# Intel<sup>®</sup> StrongARM<sup>\*</sup> SA-1111 Microprocessor Companion Chip

Specification Update

*March 2000*

Order Number: 278260-008

Figure 2-1. SA-1111 Block Diagram

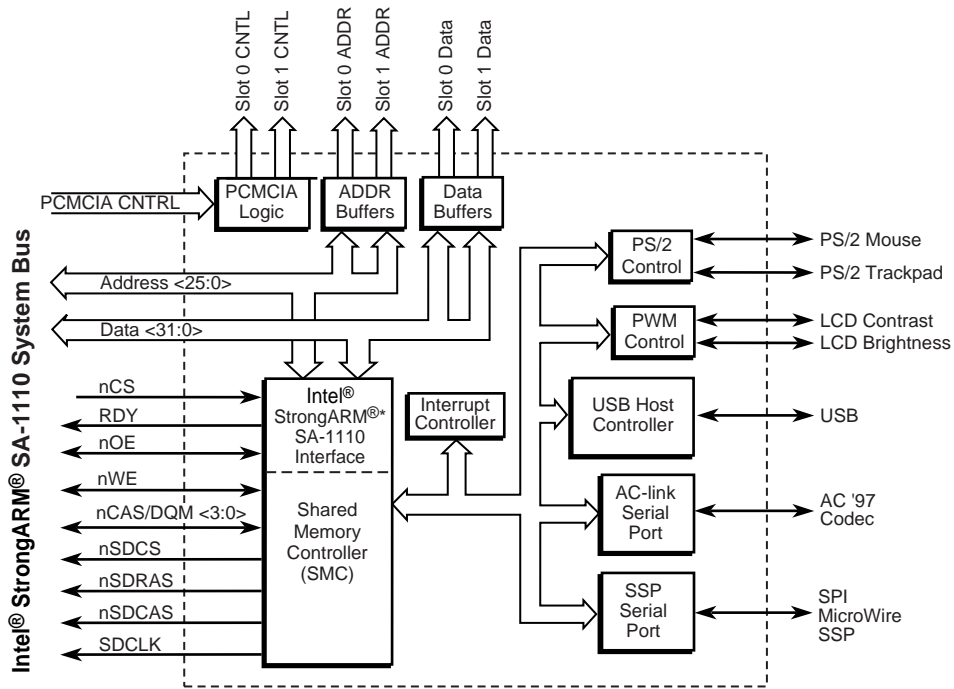
Changed the signal nOE in Figure 2-1 from an input to a bi-directional arrow. Figure 2-1 now appears as follows:

**Figure 3-7. SDRAM Read Cycle, Burst of 2 - CAS Latency = 3**

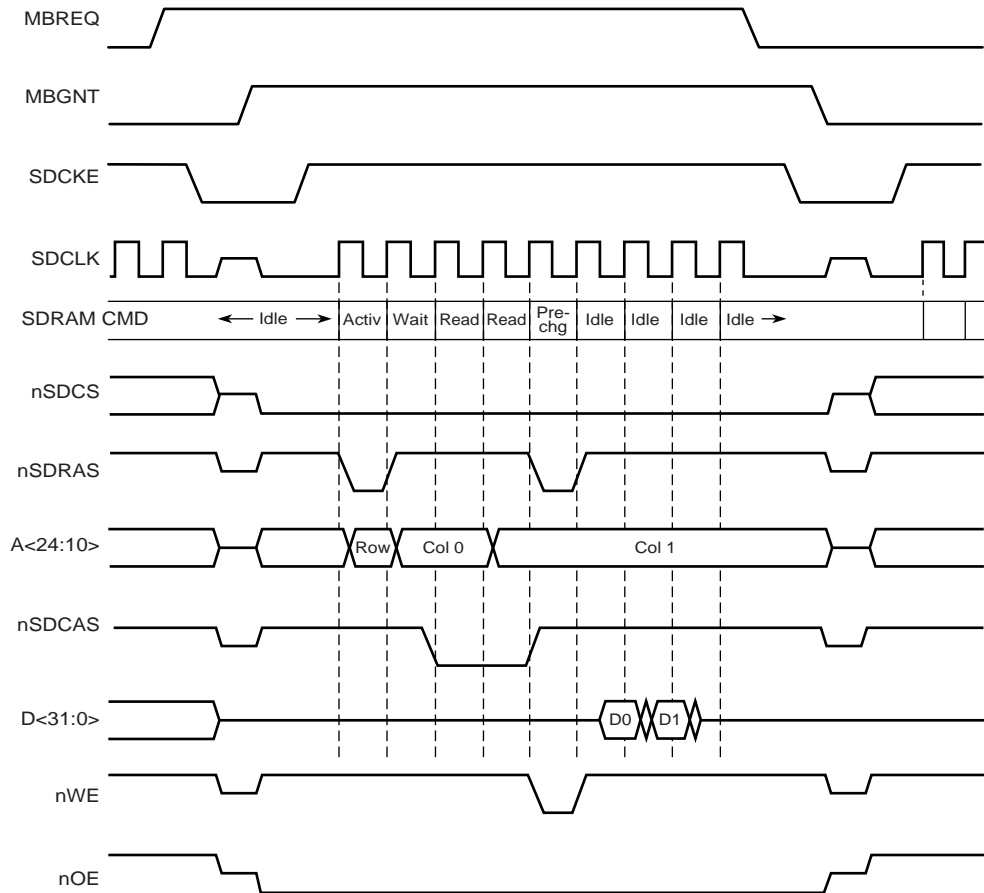
Signal nOE added to bulleted list, added text to this section, updated Figure 3-7 and Figure 3-8. This section now appears as follows:

The SMC also drives signal nOE during DMA transfers. The behavior of nOE is programmable for use in systems with different bus architectures. The nOE behavior may be enabled or disabled. For example, a design may limit system bus loading by placing buffers and transceivers between the SA-1110 (with its system memory) and other peripherals, including the SA-1111. For DMA cycles, the SA-1111 must move data through the transceivers in either direction, depending on whether it is a read or write transfer. Signal nOE may be used to control transceiver direction if it is enabled. When enabled, it is asserted low on reads to SDRAM, and remains high for writes.

Other systems may not require nOE assertion for DMA transfers. If it is disabled, nOE is still driven by the SA-1111 but remains high (deasserted) for both reads and writes.

Figure 4-1. Decoder Block Diagram

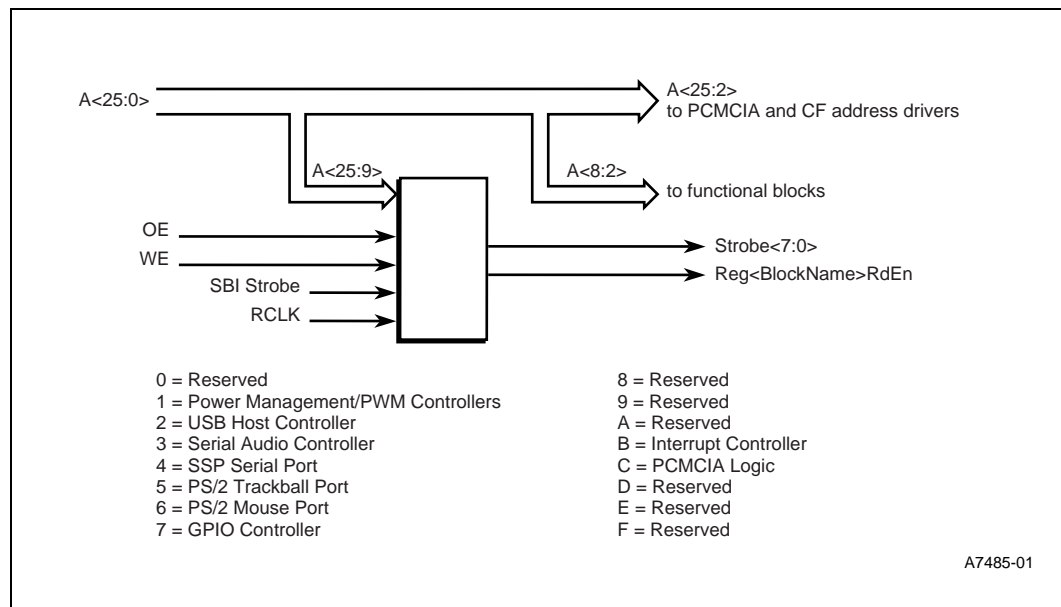
Updated address assignments in Figure 4-1. Figure 4-1 now appears as follows:

**Figure 7-4. MSB-Justified Data Formats (16 bits):**

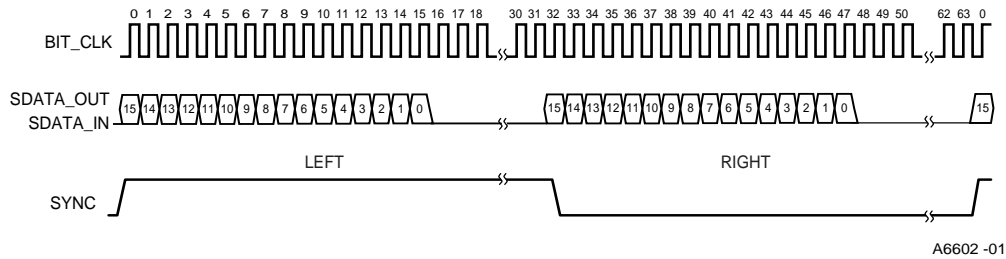
Update Figure 7-4 MSB-Justified Data Formats (16-bits). Figure 7-4 now appears as follows:
